SUBJECT: Addendum No. 2
El Dorado Trail Improvement Project, Forni Road to Missouri Flat Road
(Bid # GS 08-1021)

Addendum No. 2 contains the following changes to the Contract Specifications for the above referenced project.

ADDENDUM No. 2 - EXHIBIT "2"

SECTION A-A

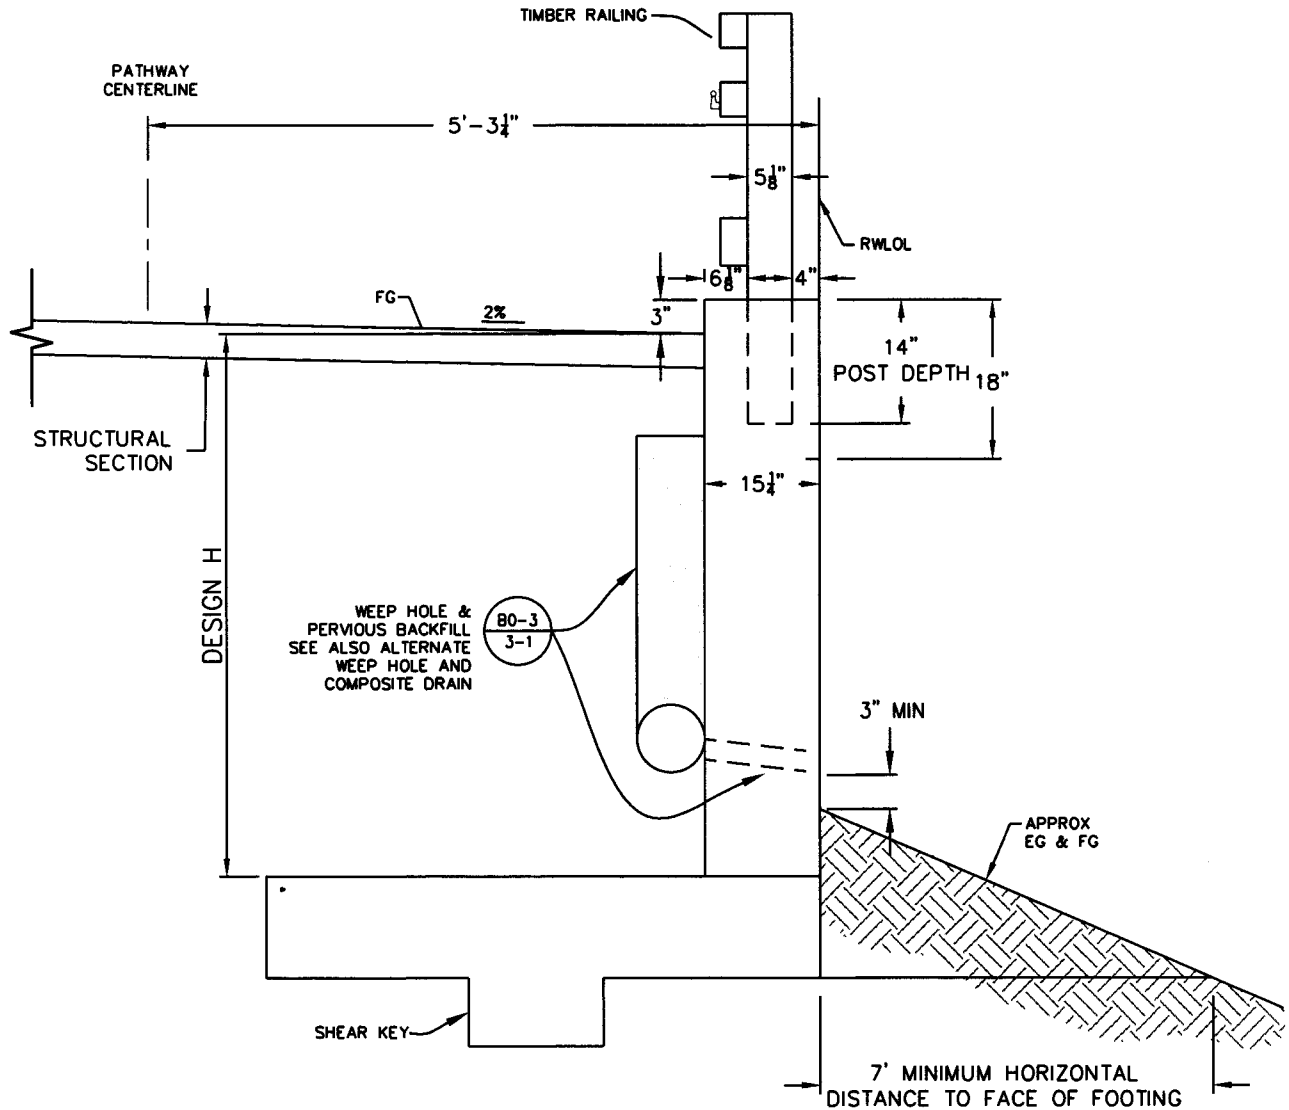
2.21	Plan Sheet C19	SECTION A-A Replace "Section A-A" detail with "Exhibit 2" attached.
2.22	Plan Sheet C19	RETAINING WALL PLAN VIEW STA 33+40.00 TO STA 34+12.00 RETAINING WALL PLAN VIEW STA 35+50.00 TO STA 37+54.00 Replace RWLOL dimension "4-11 1/2'" with "5-3 1/4'"

Exhibit 2: Replaces Section A-A on Plan Sheet C-19
